MODIFICATION RECOMMENDED

N5244A-03A

S E R V I C E N O T E

N5244A PNA Series Microwave Network Analyzers

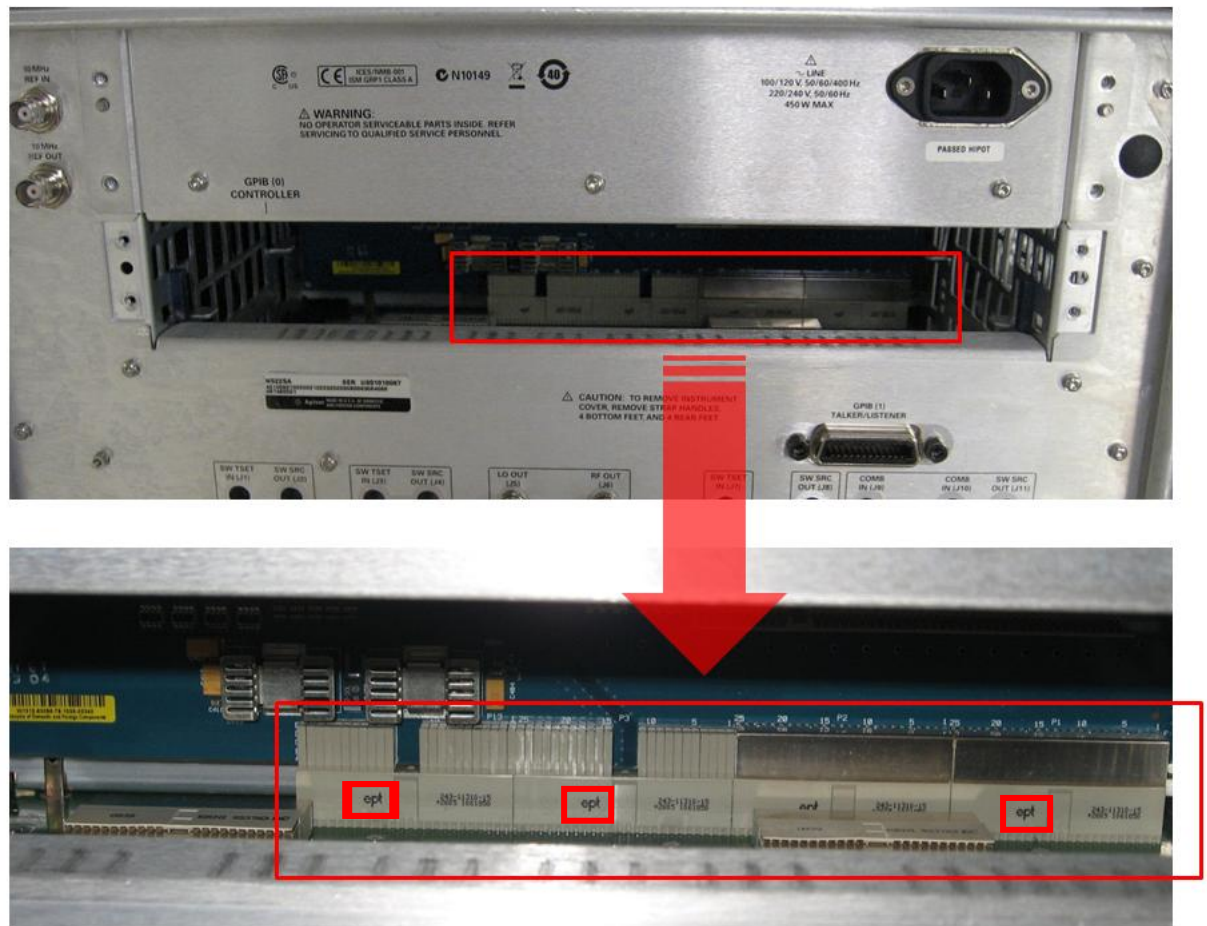
1. Remove the CPU assembly from the analyzer's rear panel. Refer to the PNA Service Guide chapter 7 section titled, "Removing and Replacing the CPU Board Assembly" for removal and reinstallation procedures. To view the online Service Guide, see the numbered list on the next page for instructions.
2. As per the photo below, inspect the system motherboard connector to see if it has one or more "ept" logos.

3. If the connector has one or more “ept” logos, return the analyzer to Agilent for replacement of the system motherboard. If the connector does not have one or more “ept” logos, email ctd-soco_support@agilent.com, providing the analyzer model and serial number and details of the malfunction symptoms.

4. *For Agilent Service Technicians only:* Only new boards without “ept” logos should be installed. Before installing the new board, look to see if it has one or more “ept” logos. If so, email ctd-soco_support@agilent.com, providing the analyzer model and serial number. Wait for further instructions in an email reply. New boards without “ept” logos can be installed. For installation instructions, refer to the PNA Service Guide chapter 7 section titled, “Removing and Replacing the System Motherboard.” To view the online Service Guide, see the numbered list on the next page for instructions.
